# CITY OF KIRKLAND

## MAINTENANCE CENTER STORM WATER POLLUTION PREVENTION PLAN (SWPPP) UPGRADES JOB NO. 43-20-PW CIP No. SDC1080000

### **ADDENDUM No. 1** **TO THE PLANS, SPECIFICATIONS, PROPOSAL AND CONTRACT**

Issued This Date: Friday, September 18, 2020  
Bid Opening: **Unchanged – September 23, 2020**  
Place of Opening: Online (link available in Invitation to Bid)

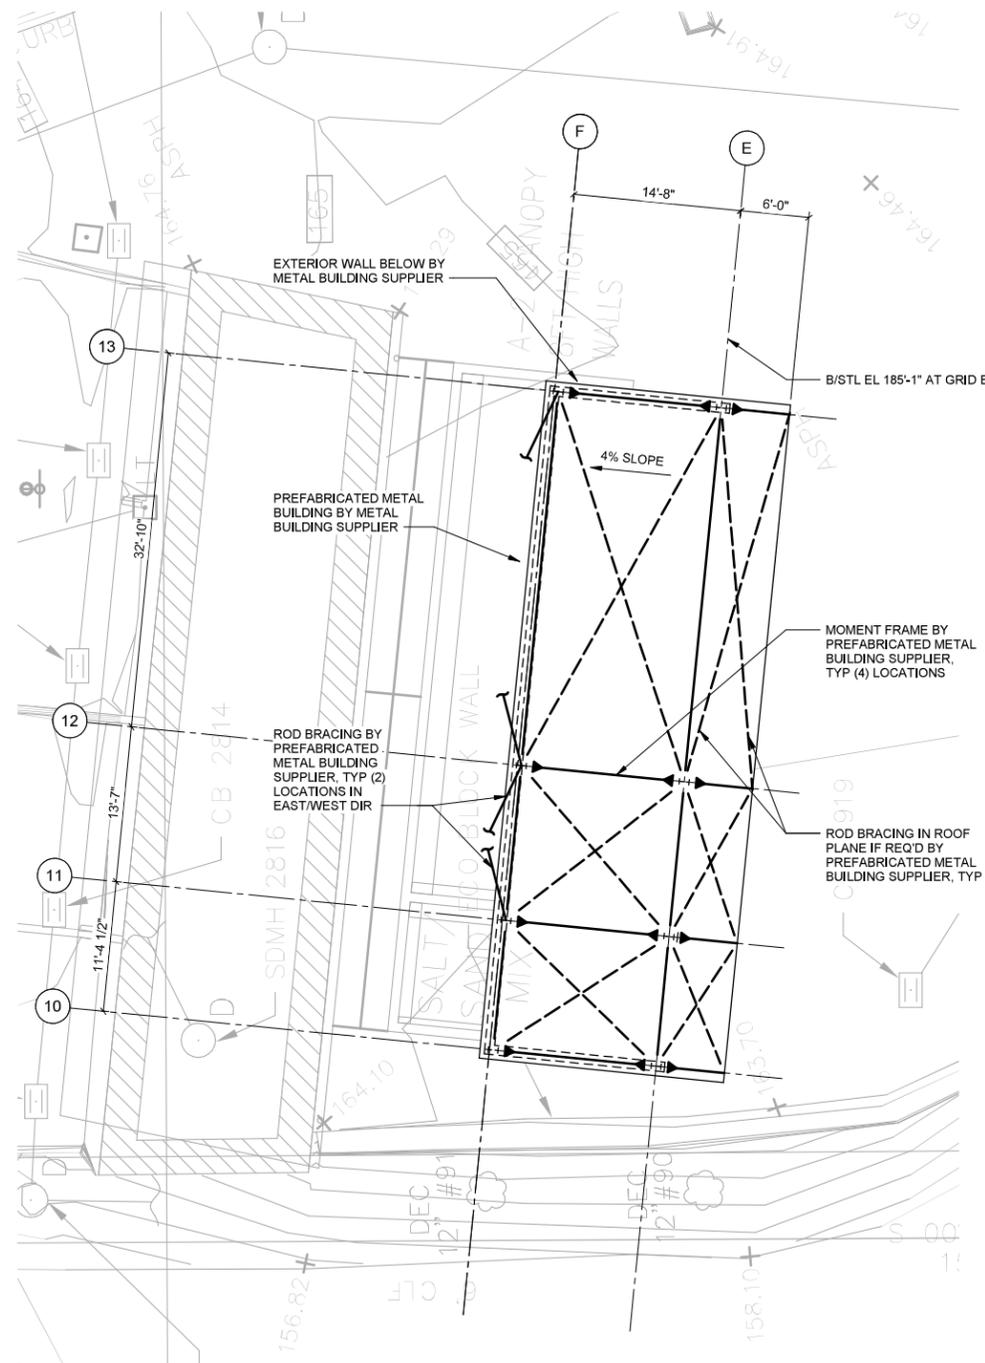
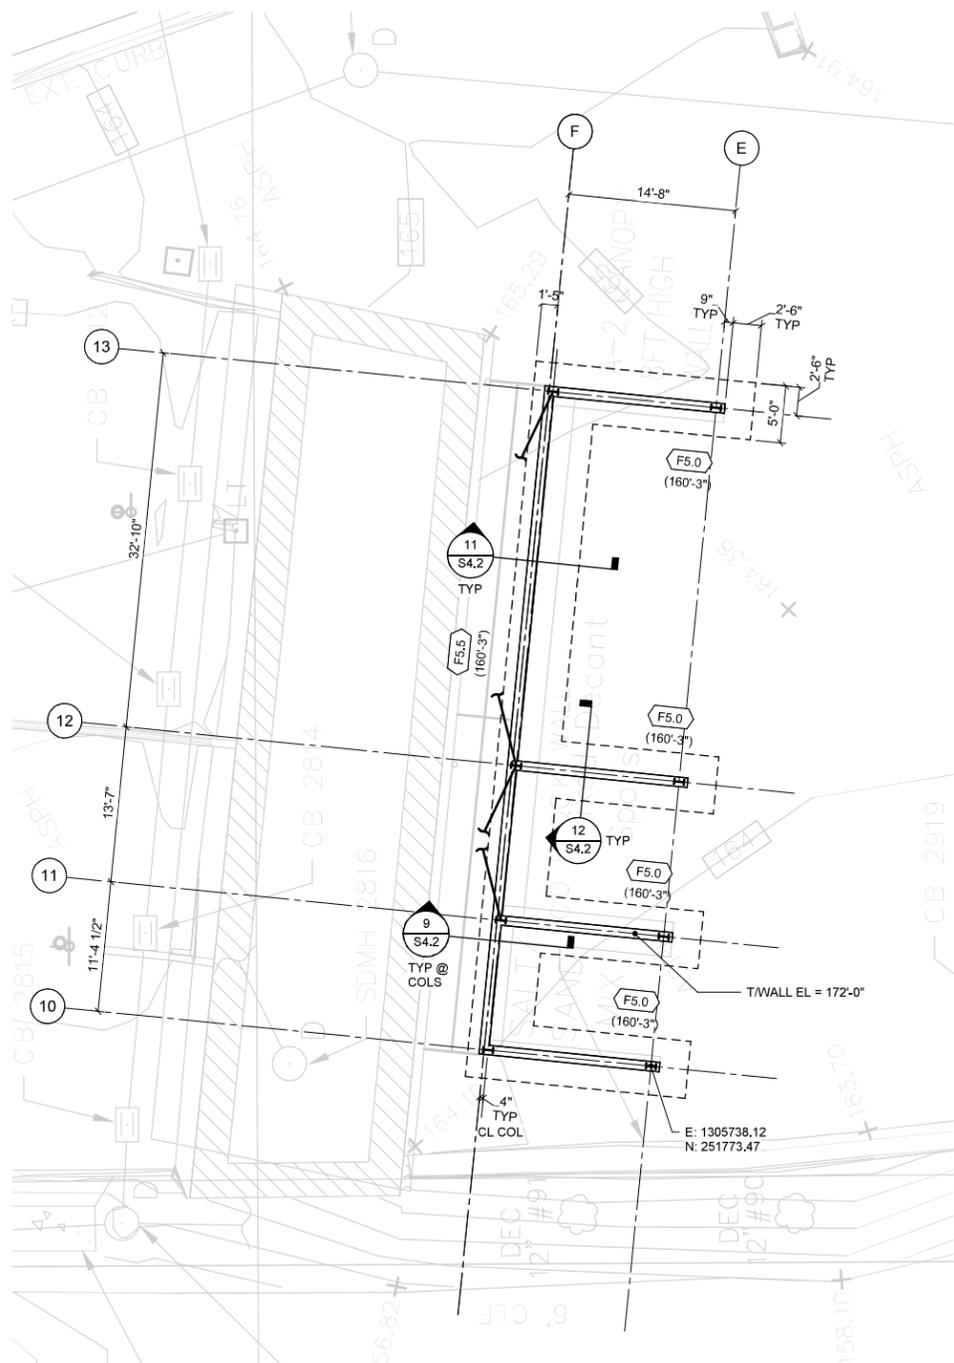
3. The PEMB is called out to have a clear height of 20' from the purlins to the paved surface but I do not see the height of the concrete wall.

*Please refer to S2.2 through S2.5 of the Plans for the top of concrete wall elevations.*
